OUC SUBSTATION EXPANSION & GAC VESSEL IMPLEMENTATION

SUMMARY

Applicant's Request: A Conditional Use Permit (CUP) amendment is being requested to expand the existing electrical OUC substation (a major utility/public benefit use) and to also update the water plant portion of the property via installation of Granular-Activated Carbon (GAC) vessels in the north parking lot. The property is located in the North Quarter neighborhood west of Lake Highland.

Staff Recommendation: Approval of the CUP amendment, subject to conditions in this staff report.

WALL DETAILS

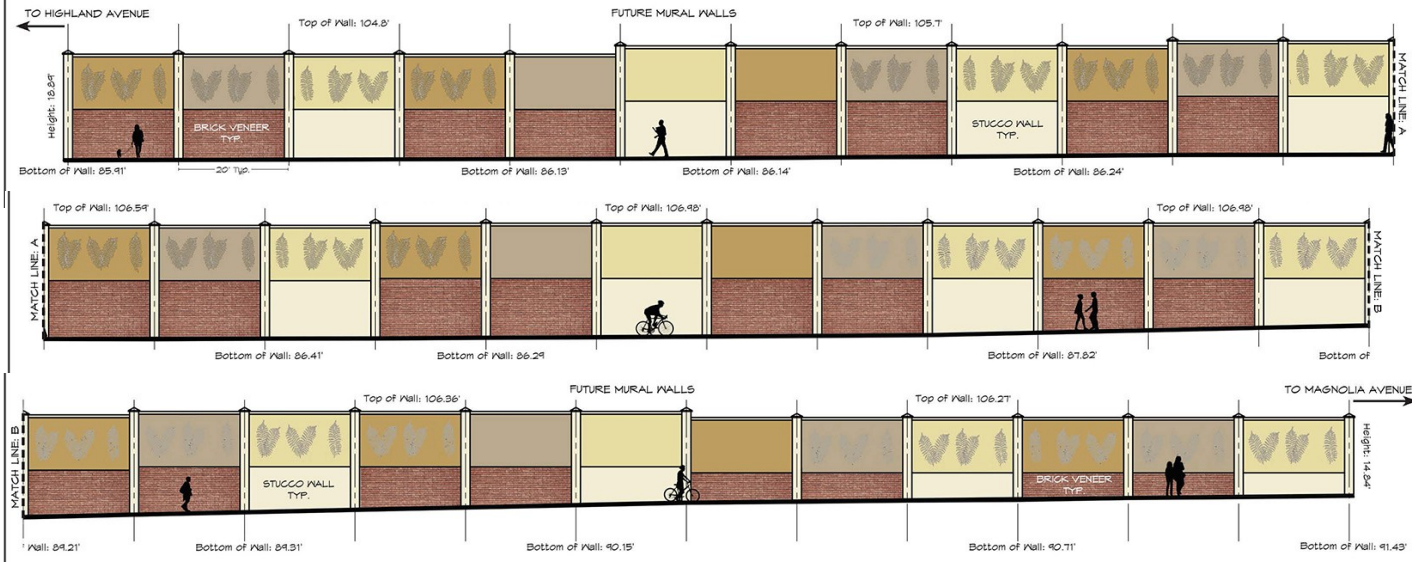
2. Wall Treatments - The conceptual wall design should be modified to include:
 - A. Pineapples - In the early 1900's the area around Lake Ivanhoe was the most prolific pineapple growing area in the country. A pineapple should be utilized for the embossed wall image along with the ferns shown in the submitted wall elevations.

- B. Brick base - All areas along the wall below the horizontal trim band on the north and east walls should be the brick pattern. Those panels shown without the brick treatments should be converted to the brick pattern.

- C. The location of the mural panels should be adjusted so the top of the mural panels in not even and not interrupted by a wall elevation change.
3. Landscaping - Add additional trees to the retention pond area, especially along the southern side of the pond to help screen views of the GAC facility.
